ATTACHMENT 1

Responses to NRC Requests for Additional Information (RAIs) on WCAP-17096-NP, Rev. 3

CE-ID: 1.1
Core Shroud Assembly (Bolted) - Core Support Column Bolts

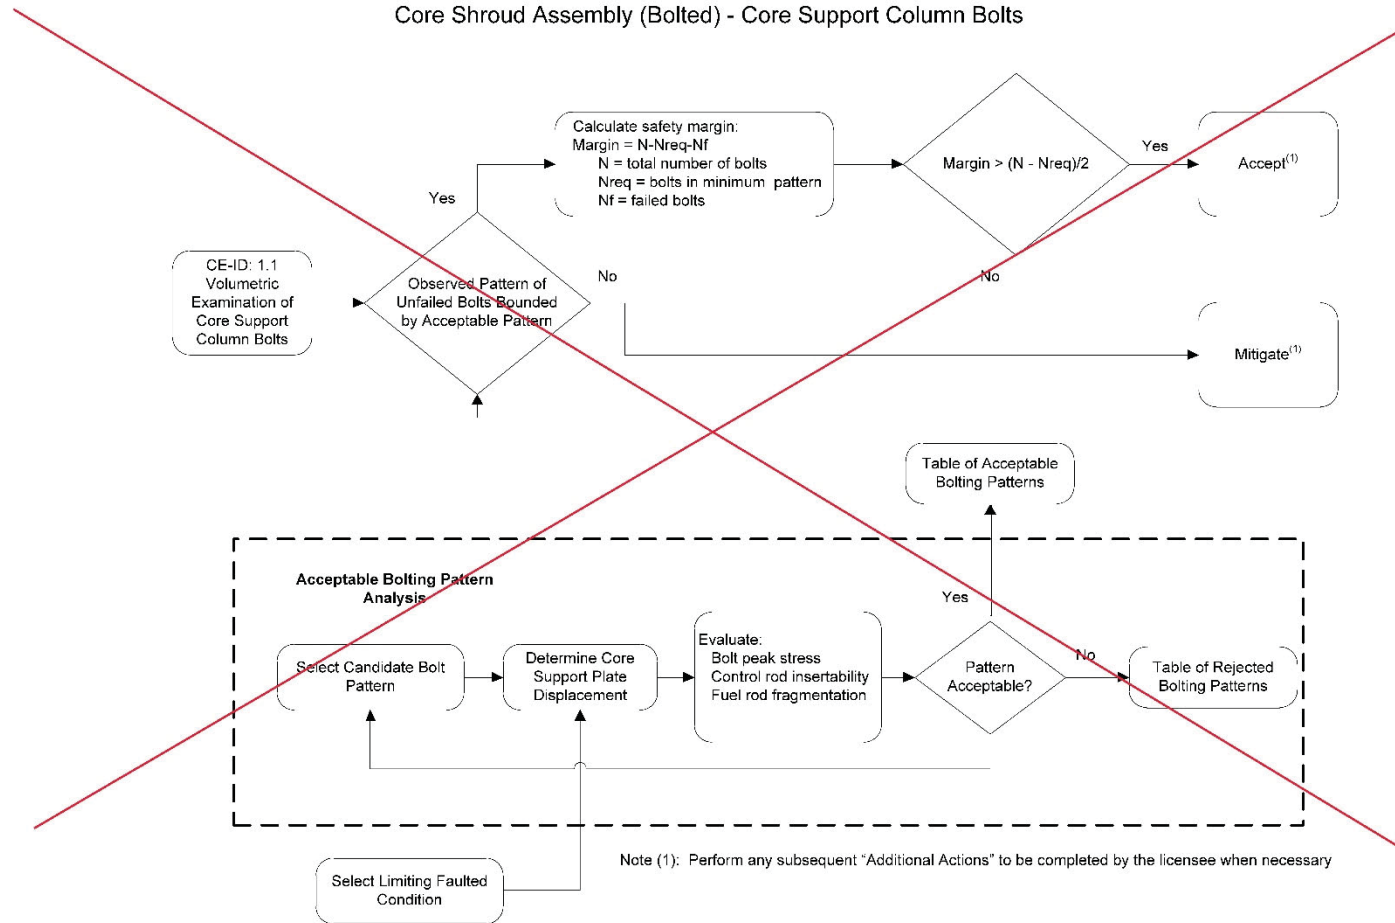
These changes are shown by the removal of CE-ID: 1, CE-ID: 1.1, and CE-ID: 1.2 from the list of CE components on page 7 of Attachment 2, in the removal of CE-ID: 1 for Core Shroud Bolts on pages 8 and 9 of Attachment 2, in the removal of CE-ID: 1.1 for Core Support Column Bolts on pages 10 and 11 of Attachment 2, and also in the removal of CE-ID: 1.2 for Barrel-Shroud Bolts on pages 12 and 13 of Attachment 2. The flowcharts for CE-ID: 1, CE-ID: 1.1, and CE-ID: 1.2 were removed as shown on pages 18-20.

~~Expect final acceptance based on plant-specific analysis.~~

~~Note that the licensee shall submit the plant specific analysis for the acceptable distribution of intact components within one year after any inspection that triggers the expansion criteria as defined in Table 5-2 of MRP-227.~~
